Access Compliance Report

Public Rights-of-Way

(Curb Ramps)

Intersection ID: 16452	Main Street: STANFORD_PL	Cross Street: WELLESLEY_AV	Location:	N
ADA ID: 5C2DDEC0F1F8	Ramp Type: PerpDiag	Initial Pass/Fail: Fail	Overall Compliance: No	Severity Score: 12.5

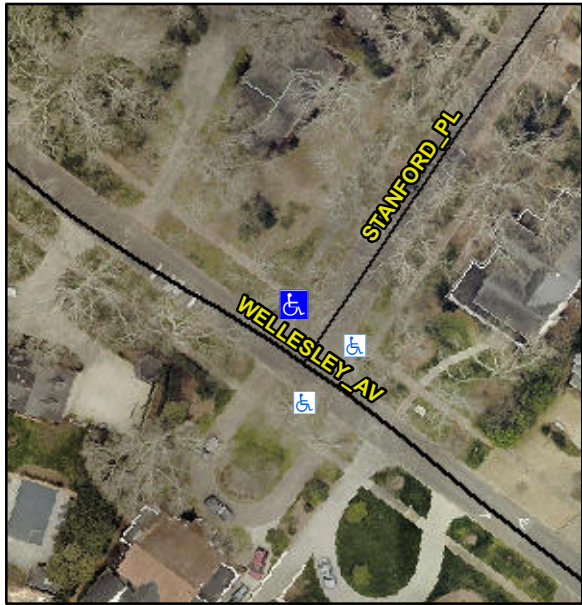
Codes/Mitigation Info/Possible Solution			Field Measurements/Component Compliance					
	Possible Solutions:		Compliance	Description	Data	Compliance	Description	Data
	Remove & Replace Curb Ramp With Two New Directional Ramps or Equivalent.		N/A	Ramp Length (in)	78.0	No	Ramp Slope (%)	8.5
			Yes	Ramp Width (in)	48.0	Yes	Ramp XSlope (%)	0.9
			N/A	Flare Type LT	N/A	N/A	Flare Type RT	N/A
			N/A	Flare Slope LT (%)	N/A	N/A	Flare Slope RT (%)	N/A
			N/A	Flare Traversable LT?	N/A	N/A	Flare Traversable RT?	N/A
			N/A	Landing Length (in)	N/A	N/A	DWS Provided?	N/A
			N/A	Landing Width (in)	N/A	N/A	DWS Contrast?	N/A
			N/A	Landing Slope (%)	N/A	N/A	DWS Length (in)	N/A
			N/A	Landing X Slope (%)	N/A	N/A	DWS Full Width?	N/A
Surveyor Notes:			N/A	Landing Curb? (Y/N)	N/A	N/A	DWS Offset (in)	N/A
N/A			N/A	Shared Landing?	N/A			
PROW/ADA:			N/A	Gutter Ponding?	N/A	N/A	Gutter Slope (%)	N/A
R304.2.2			N/A	Gutter Lip Ht (in)	N/A	N/A	Gutter X Slope (%)	N/A
